ADDENDUM NO. 2

GRANGER-HUNTER IMPROVEMENT DISTRICT, UTAH ANDERSON WATER TREATMENT PLANT PROJECT

November 20, 2024

DRAWING:
D-101

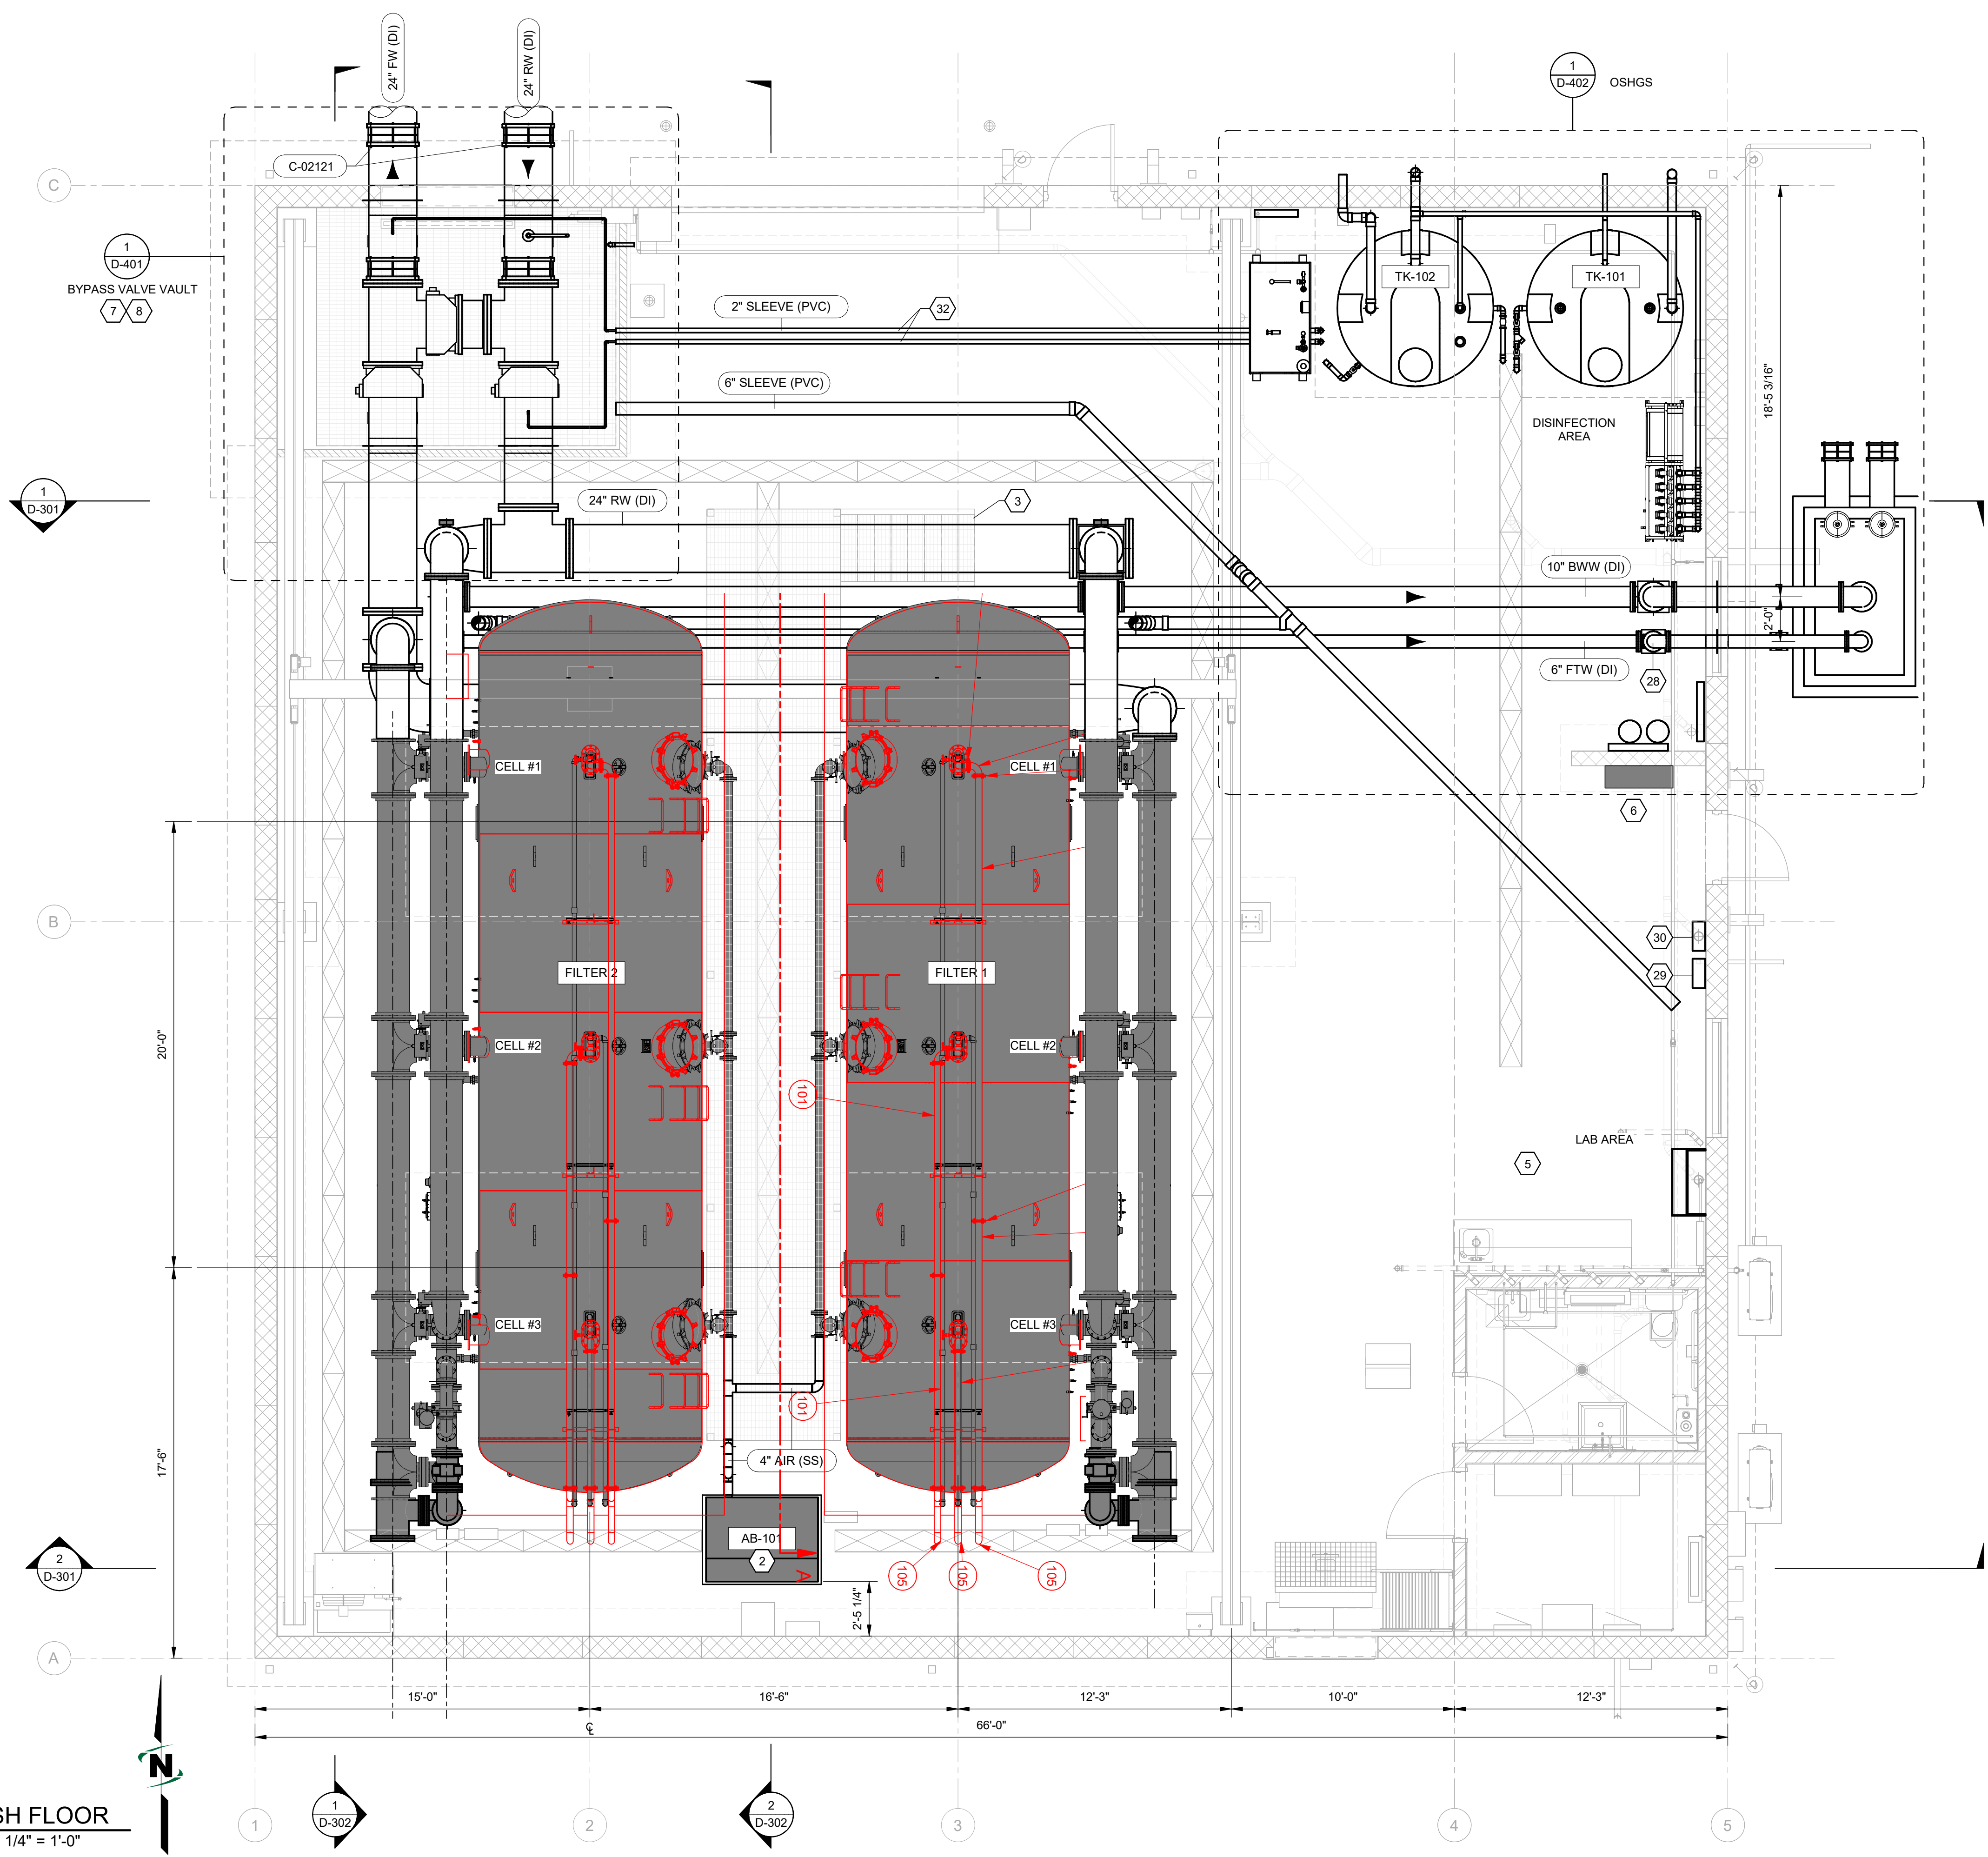
Comment #	Specification or Reference	Item Description	Submittal Designation	Comments
-	-	-	-	See attached comments from Electrical Engineer.
1	1.5 & 1.7.A.8	Warranty	1	No Exceptions Taken. Remove the redundant warranty from the electrical submittal.
2	1.6.A.1-2	Mechanical Drawings GA Dwg and Layout	-	Schedule a conference call to discuss (see attached overlay redlines): <ol style="list-style-type: none"> 1. Thank you for matching the filter spacing to what's shown in the bid set drawings. 2. Air wash valve piping appears to clear the catwalk columns by 1-inch. More clearance (approx. 3-inches) would be preferred to avoid interferences during installation. Verify the air wash valve can be rotated 90-degrees to avoid interference with the catwalk joists.

Comment #	Specification or Reference	Item Description	Submittal Designation	Comments
				 <p>Needs to rotate 9-degrees to avoid interference with catwalk. Extend out 2" more if possible to avoid interference with catwalk column.</p> <p>Why is valve off-center?</p>  <p>Filter-to-waste valve needs to rotate 90-degrees to avoid interference with BWW.</p> <ol style="list-style-type: none"> Why is a valve off-center on Left Side View on drawing 100058465? Filter-to-waste valve needs to rotate 90-degrees to avoid interference with backwash waste piping. <ol style="list-style-type: none"> Re-submit mechanical drawings to match layout as shown on the attached redlines: List the operating weights (needed for structural design of the filter support pads). Only vessel weight provided without concrete on drawing 100058440.
3	1.6.A.3	P&ID	2	<p>Schedule a conference call to discuss:</p> <p>Previous comment: Redline the P&ID (I-004A/B) in the attached bid set if changes are needed or provide a new P&ID.</p>
